- Subject: Environmental & CRZ Clearances for the proposed "Development of All-weather, Multi cargo, Greenfield, Captive Jetty(ies) for handling capacity 52 MTPA at Jatadhari Muhan River, District Jagatsinghpur, Odisha by M/s JSW Utkal Steel Limited." [Proposal No. IA/OR/MIS/74417/2018; F. No. 10-68/2018-IA.III]
- **Ref.:** 256th & 260th Minutes of the meeting of Expert Appraisal Committee (EAC), Infra 1.

ADDENDUM EIA REPORT

PROJECT: Development of All-weather, Multi cargo, Greenfield, Captive Jetty(ies) for handling capacity 52 MTPA at Jatadhari Muhan River, Dist. Jagatsinghpur, Odisha by M/s JSW Utkal Steel Limited. [Proposal No. IA/OR/MIS/74417/2018; F. No. 10-68/2018-IA.III]

The proposal has been appraised by the EAC during 256th meeting held on 3rd March, 2021 and 260th meeting held on 5th April, 2021 and sought additional study reports/documents for further appraisal by the committee for its environmental and CRZ clearance. The requisite addendum study reports prepared are summarized and submitted in the following section.

Figure 4: Water fogging system in the unloading hopper (also refer Figure 1)

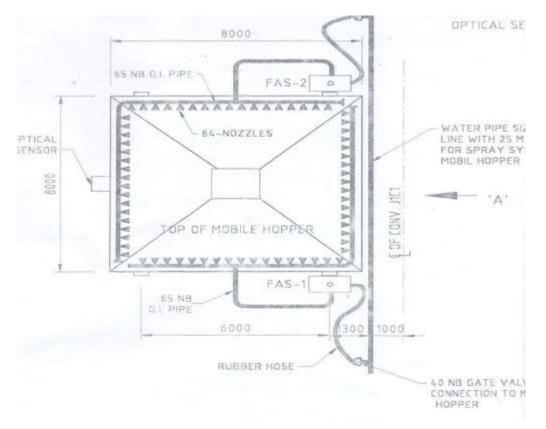
S. No.	Observation by EAC	Our Submissions
1	Study on impact of Coal and	Coal movement and receipt at the captive jetty facility is only
	its movement/ storage shall	through ship, and there is no rail/road movement is
	be submitted.	envisaged.
	Details on whether the coal is	The coal requirement for steel plant is to be imported from
	shared with other units of JSW	countries like Australia, Canada, Russia, South Africa,
	in India shall be submitted.	Columbia and Indonesia through sea route.
		The coal handling at the jetty facility is under controlled
		conditions to contain the fugitive emissions by implementing
		a series of pollution control measures through highly
		mechanization, including its storage in the longitudinal cover
		shed to further arrest air pollution.
		The coal handled at the jetty facility is mainly for captive use
		at the proposed ISP, and shall not be transported to other
		JSW facilities in the hinterland.

Figure 4 shows the arrangement of the fogging system on the Hopper, which is shown under working condition in earlier Figure 1.

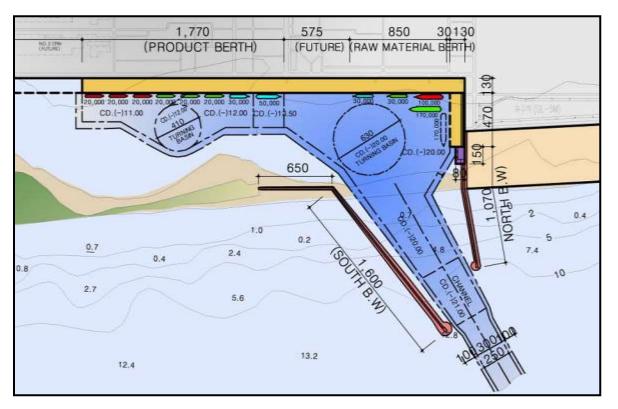
Dredging work in creeks, its usage and disposal patterns need to be elaborated. The impact of disposal in sea to the nearby ports shall be evaluated and submitted.

The Captive Jetty is located on the left bank of the Jatadhar River. The layout of the port highlighting the dredging area and the corresponding dredged depths inside the creek and the inner channel is shown in the Figure 1.

Hence, as per computations, the inner channel and the creek area (as per the Figure 1) is likely to generate about 20 - 25 Million Cubic Meter of dredged spoils.
